CS Memorandum No. 1471

Subject: Configuration Management Board Meeting No. 128

CMB Meeting Minutes #128

SUBJECT: Configuration Management Board Meeting # 128 – Rev. No. 0

CONTRACT NO. 1254R
SFMTA CONTROL NO. CL-19901
DRAWING NO. AR-114
SHEET NO. 413
REVISION 3

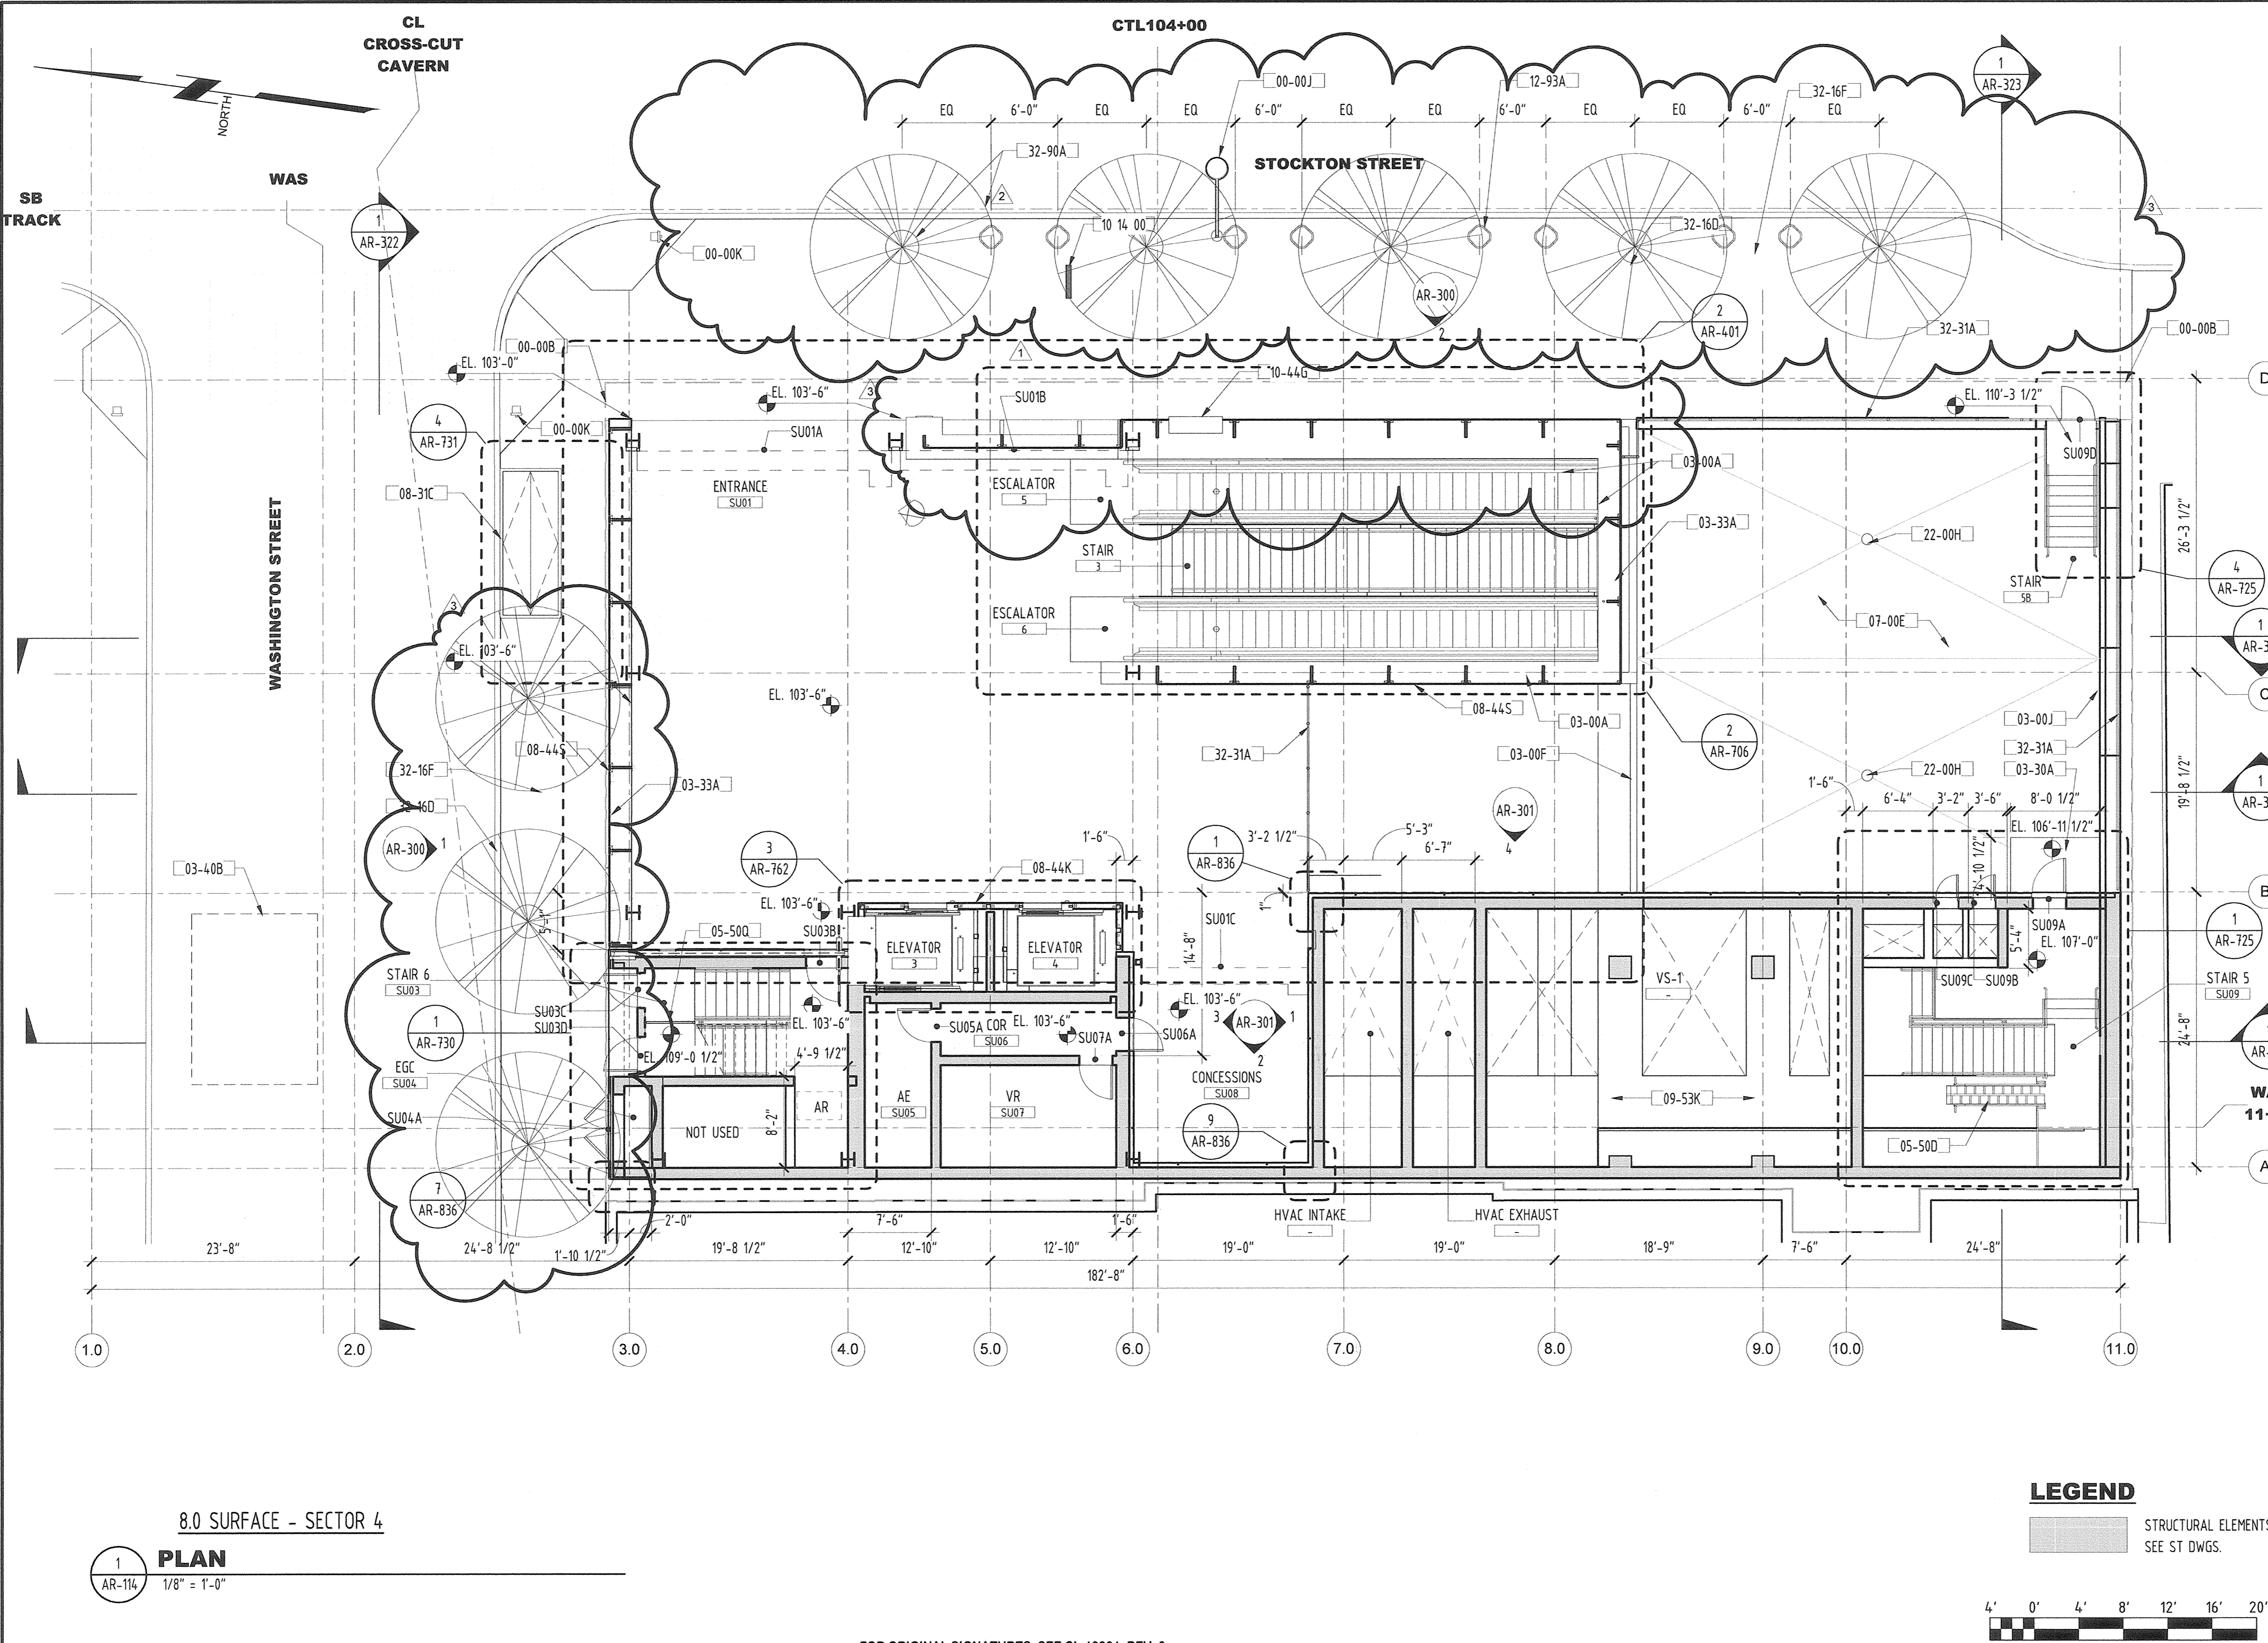
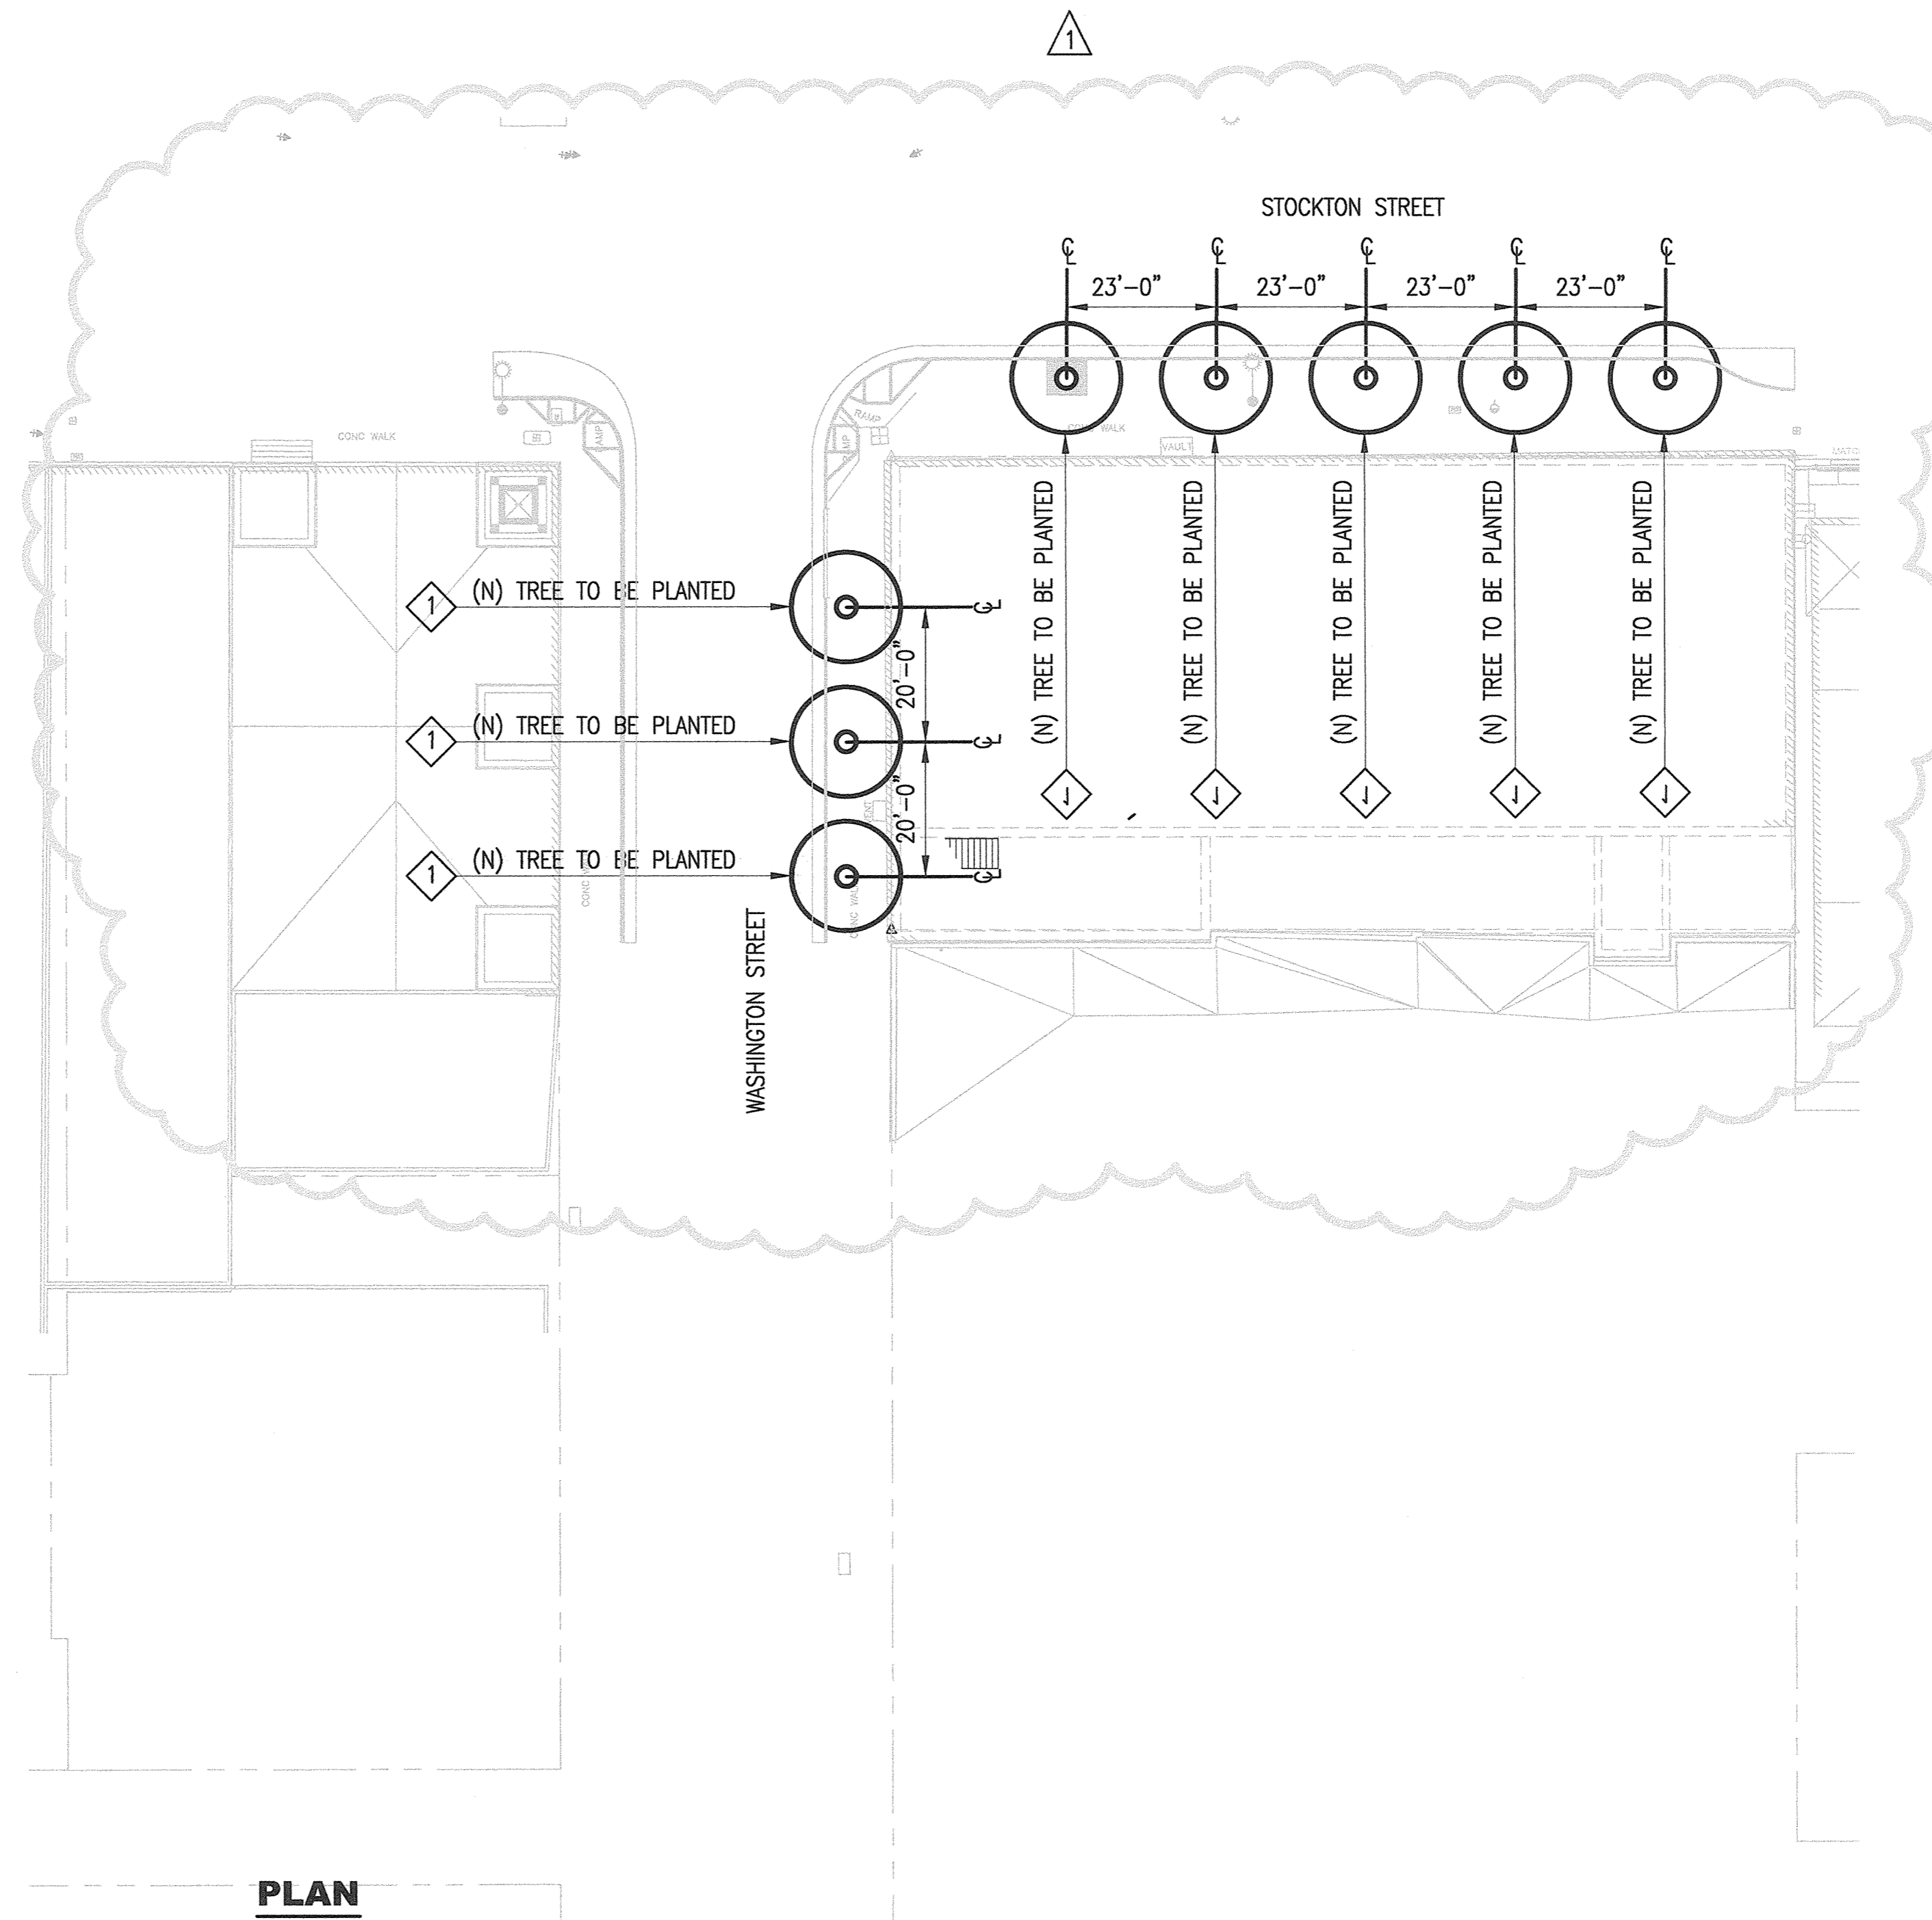
Approved for Distribution By Discipline Lead: Mona Tamari, Architectural (Kwan Henmi)	Date: 6/5/13	Signature:  for Mona Tamari
Comments: Bike racks were incorporated via addendum; any revisions to accommodate bus stop would need to be addressed via construction change order		
Change Recommended: Yes <input checked="" type="checkbox"/> No <input type="checkbox"/>

- a. SF Planning GPR requirement for **elongated bulb-out on Stockton Street** included in Contract 1300 Addendum No. 3: Drawings AR-114 Rev. 3, RP-102 Rev. 1 and RP-202 Rev. 1.
- b. SF Planning GPR requirement of **trees included** in Contract 1300 Addendum No. 3: Drawing LA-100 (Rev. 1), and AR-114 (Rev. 3)
- c. ROM Construction Cost Estimate for elongated sidewalk, trees, tree wells and bicycle racks = \$36,200
- c. ROM Design Costs:
 - DPW about 97 hrs / \$16,900: Modifies four (4) drawings, coordinate w/LA and Architect plus TASC drawing for beginning sidewalk legislation;
 - CSDG 60 architectural hours: evaluation of bus berthing of different fleet vehicles, bus doors & mirrors to tree locations. Develop sketch.
- d. ECP-038 prepared for routing.
